Agenda
Village of Glen Ellyn
Capital Improvements Commission Meeting
Tuesday, June 13, 2023
7:00 PM
Glen Ellyn Civic Center, Room 301

Civil Plan – Note, these include progress review comments merely for context

TS&L Plans – Note, these include in progress review comments merely for context

GENERAL PLAN AND ELEVATION
PEDESTRIAN TUNNEL
GLEN ELLYN METRA STATION
SECTION 18-00082-00-MS
DUPAGE COUNTY
STATION 3604+41.45

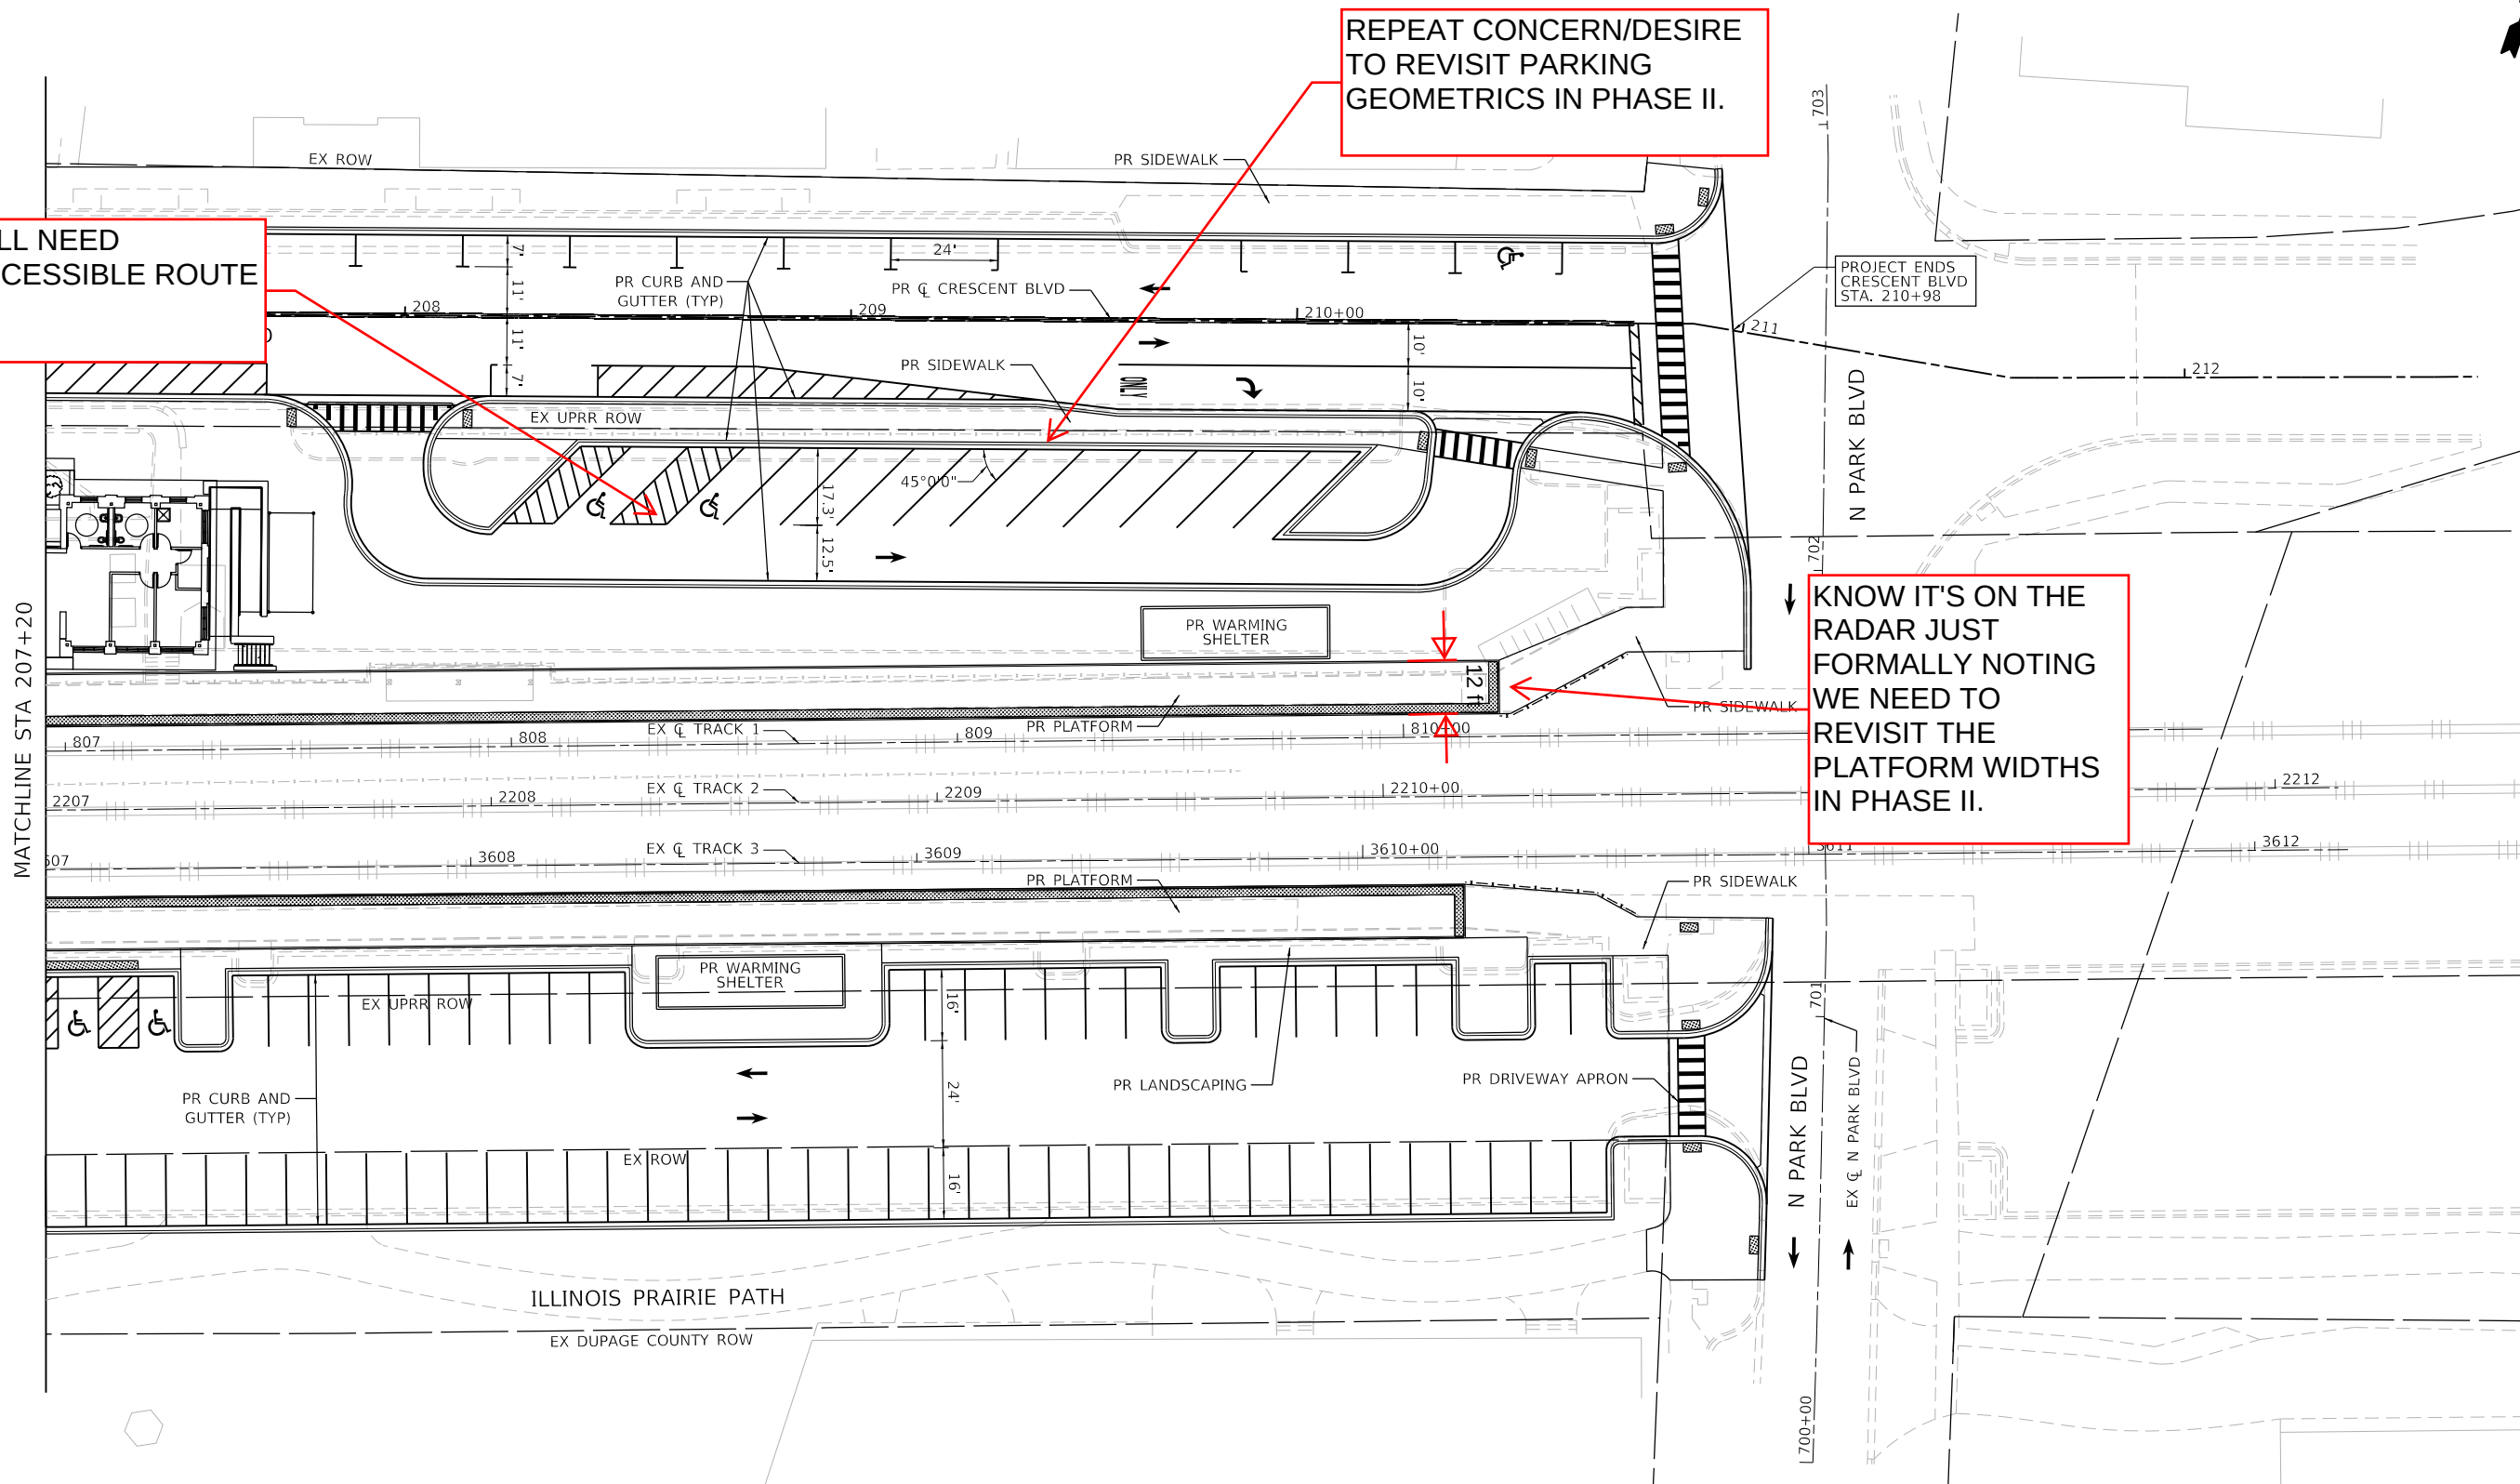
KNOW IT'S ON THE
RADAR JUST
FORMALLY NOTING
WE NEED TO
REVISIT THE
PLATFORM WIDTHS
IN PHASE II.

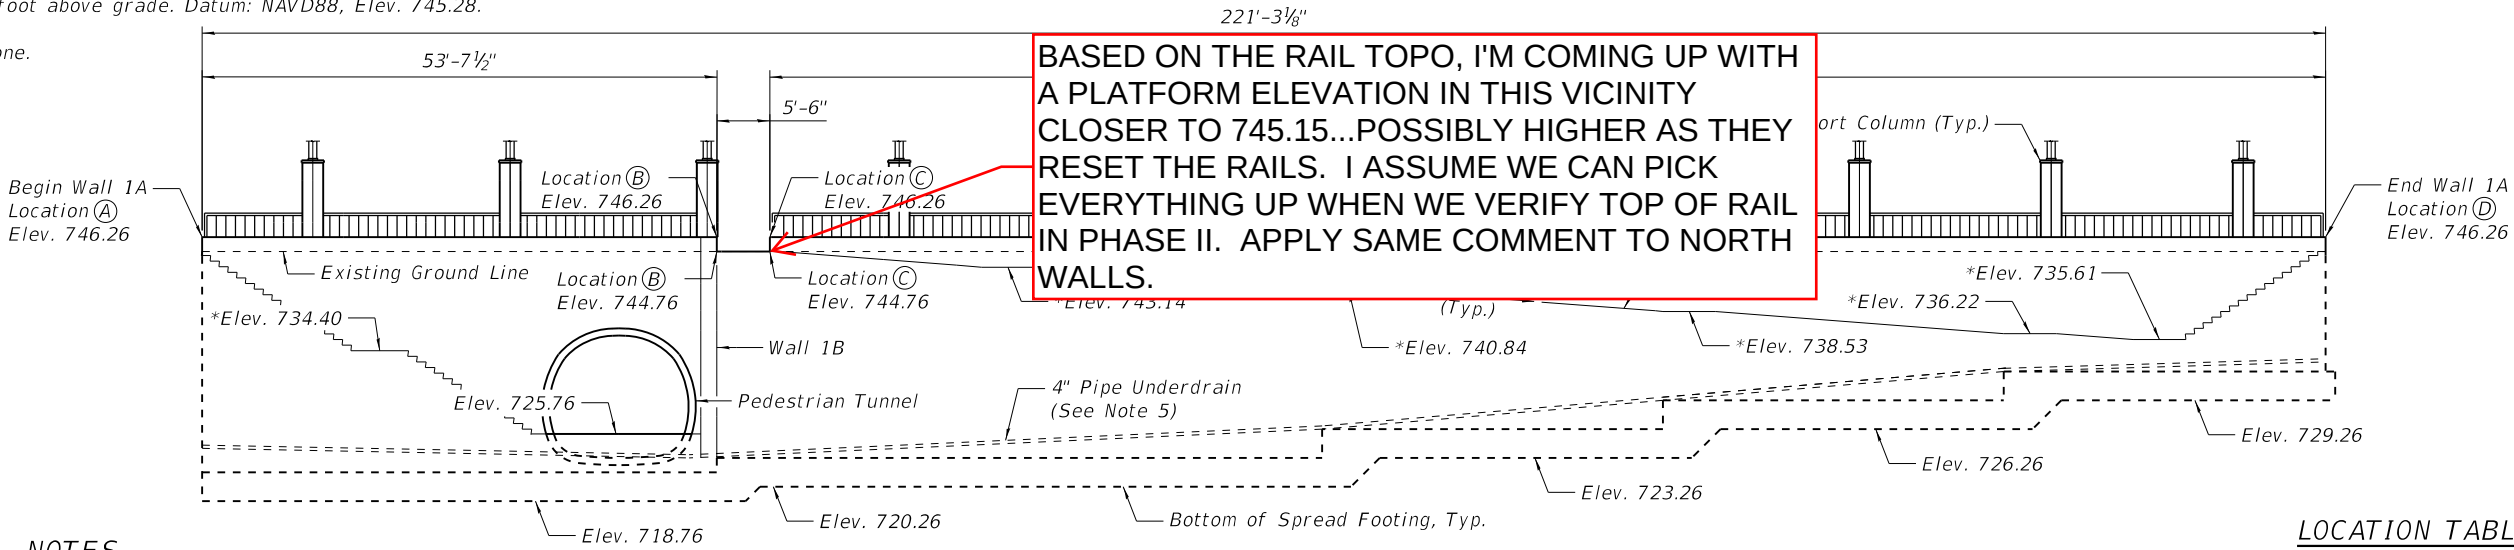
SEE SECTION A
DRAWING
COMMENT ON
DIMENSION.
